# ***Interactive comment on “Urban sewershed overflow analysis using super-resolution weather radar rainfall” by J. Y. Hyun et al.***

Reply RC1(Anonymous Referee #1) on September 30th 2016

Urban sewershed overflow analysis using super-resolution weather radar rainfall  
(Manuscript Number. hess-2016-362)

**Fig. 1.**[Printer-friendly version](#)[Discussion paper](#)

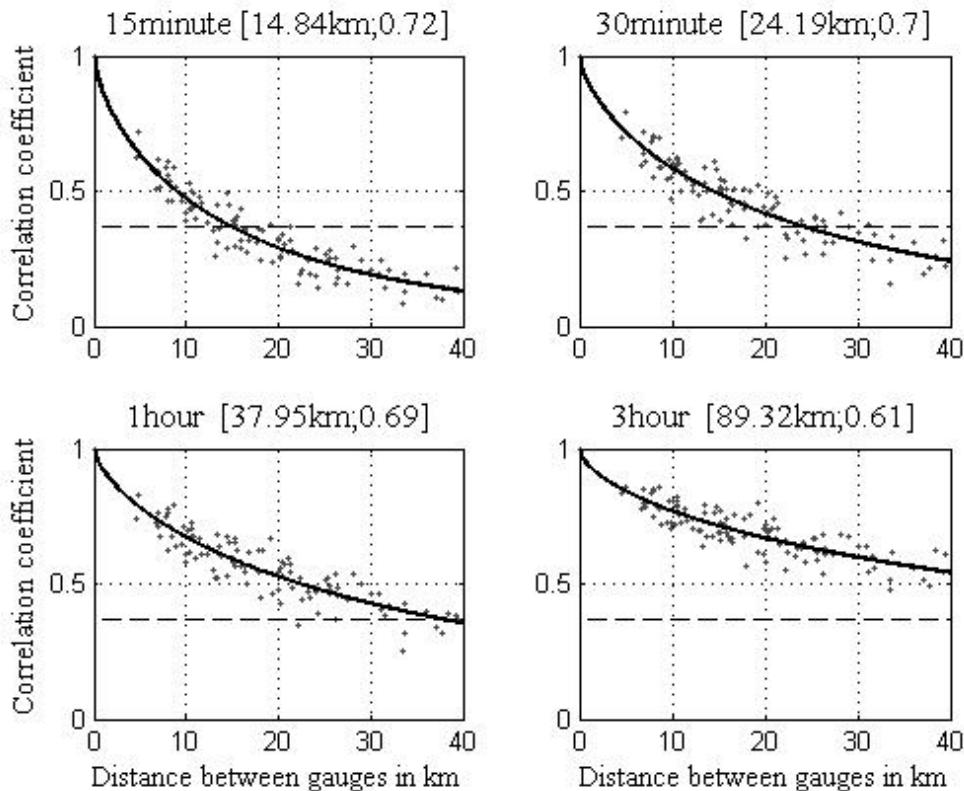
two types of tropical storms? Can the information in your research be used to identify in real-time which Z-R relationship to use, and whether it can be used to improve the prediction of CSOs? The conclusions section could be improved. You say early on that "Categorization of the severe rainfall events including CSO occurrence can provide insights for hydrologic and hydraulic design guidelines to reduce sewer overflows from combined sewer systems in an urban area". Can you say a little more about how this might be done? Could you also say more about the number of false negatives in Table2? Out of 52 events listed, you predict 11 out of 52 incorrectly? What is different about these events. If you look at Table1, the major differences seem to be rainfall intensity and total depth (the other differences aren't great. This is what you would expect. When do you make a false prediction?

Answer. In the figure 5, the two newly created tropical Z-R relationships are plotted. Through use of the Support Vector Classification with Kernel threshold of the 46 dBZ, the two groups were divided by the linear hyperplane (lower-left in figure 4). Let's back to the figure 5 (lower-right), and the tropical 2 (red-dotted) power curve takes care the underestimated group. Therefore, the matching rainfall intensity to observed reflectivity is necessary to prevent the underestimation problem. Fundamentally, a single tropical type of Z-R relationship cannot cover storm variability in extreme convective. Addressing a shift in the fit of the Drop-Size-Distribution, in this case for the tropical storm due to the reflectivity threshold of 46 dBZ, resulted in an evenly distributed set of two groups.
